**E-55412**

**Enclosure 3 to E-55412**

**Draft RAI Responses with associated SAR  
change pages**

**SAR Chapter 2, "Site Characteristics"****RAI NP-2.6-3:**

Figure 1-6  
WCS CISF Storage Pad Layout

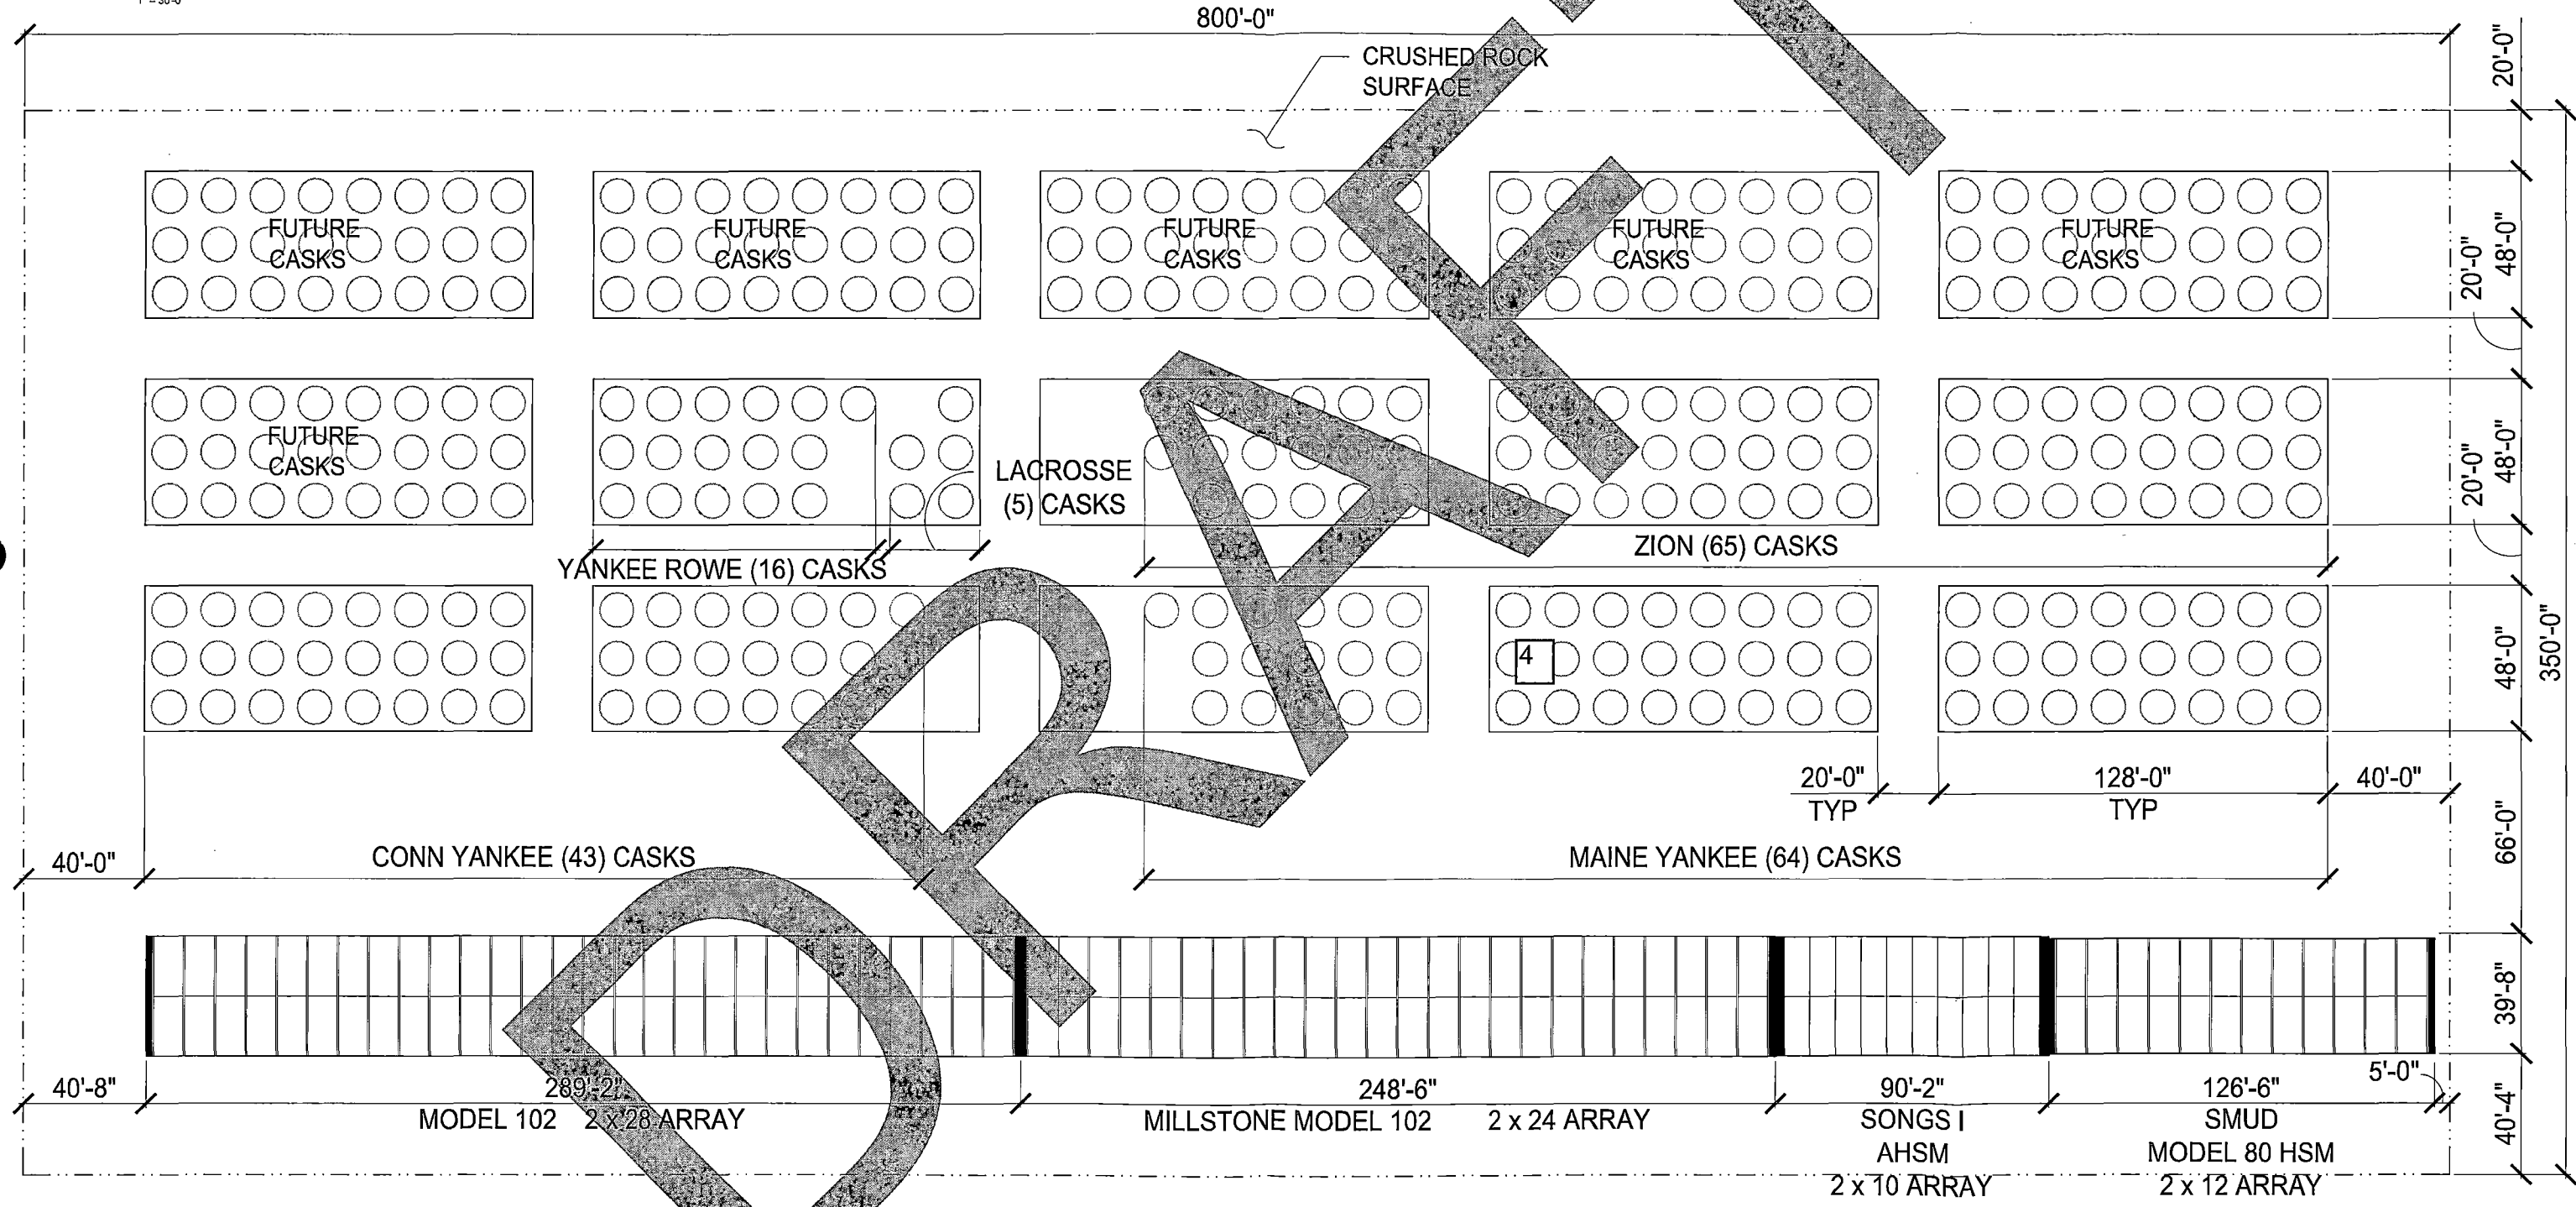
Figure 1-6. The proposed storage facility area is about 350 ft x 800 ft. Provide the total and differential settlement evaluation influenced by the layout and construction sequence.

After the iterative process outlined above was completed, the resulting stress distributions were utilized in conjunction with SAR Figure 1-6 to perform additional settlement models. By utilizing multiple pads the settlement models encompass stress overlap between pads and the resulting potential for differential settlement depending on the construction/loading sequence of the pads. The resulting Settlement Analysis is included in Appendix H of the Revised Report of Geotechnical Exploration Revision 2, which is WCS CSIF SAR Attachment E to Chapter 2.
